Project	IEEE 802.16 Broadband Wireless Access Working Group < <u>http://ieee802.org/16</u> >
Title	Correction of Figure D.8
Date Submitted	2006-11-04
Source(s)	Yerang Hur yehur@posdata-usa.com POSDATA Co., Ltd.
Re:	Call for Maintenance Change Requests on IEEE Std 802.16
Abstract	This document suggests correcting Figure D.8 in Annex D.2 Sleep Mode MSCs.
Purpose	Adopt change requests on IEEE 802.16e-2005.
Notice	This document has been prepared to assist IEEE 802.16. It is offered as a basis for discussion and is not binding on the contributing individual(s) or organization(s). The material in this document is subject to change in form and content after further study. The contributor(s) reserve(s) the right to add, amend or withdraw material contained herein.
Release	The contributor grants a free, irrevocable license to the IEEE to incorporate material contained in this contribution, and any modifications thereof, in the creation of an IEEE Standards publication; to copyright in the IEEE's name any IEEE Standards publication even though it may include portions of this contribution; and at the IEEE's sole discretion to permit others to reproduce in whole or in part the resulting IEEE S

Figure D.8 Example sleep mode - BS initiated <u>for the case of TRF_IND required =1</u> <u>and Traffic_triggering_wakening_flag = 1</u>

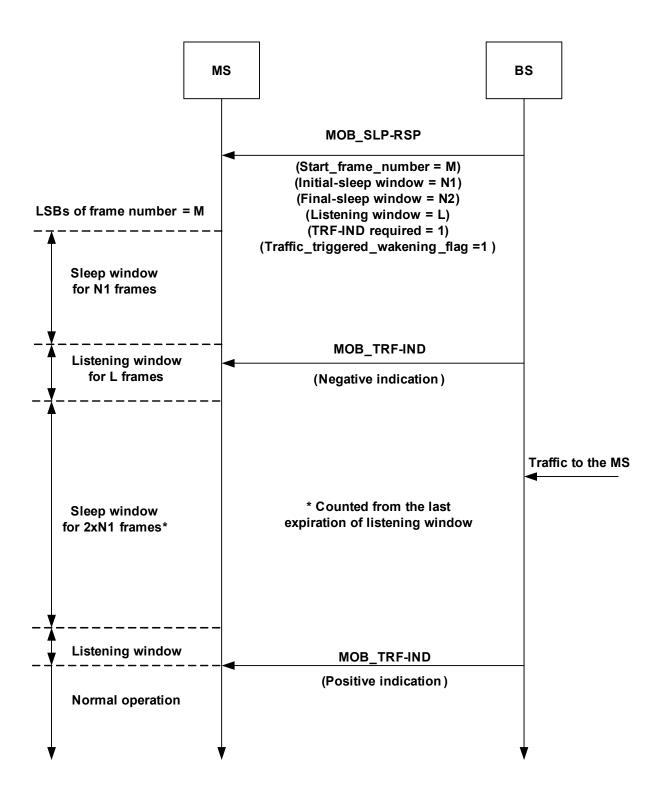
These editorial corrections are required In Figure D.8 of Annex D.2.

a. Min-sleeping interval and Max-sleeping interval are not defined in sleep mode operation. Those should be Initial-sleep window and Final-sleep window, respectively.

b. In the left side of the figure start frame of the first sleep window is incorrect. The first sleep window should start at the frame where the LSBs of the frame number is the same as Start frame defined in MOB_SLP-RSP.

c. The starting arrow of the second sleep window is not consistent with description in 6.3.21.2. The starting arrow of the second sleep window should be aligned with the end of the listening window.

Also, the size of sleep window should be counted from the last expiration of listening window according to 6.3.21.2 and Figure 130a. So description on it appearing in the figure should be corrected as well.

[Adopt a revised figure in the next page as Figure D.8:]
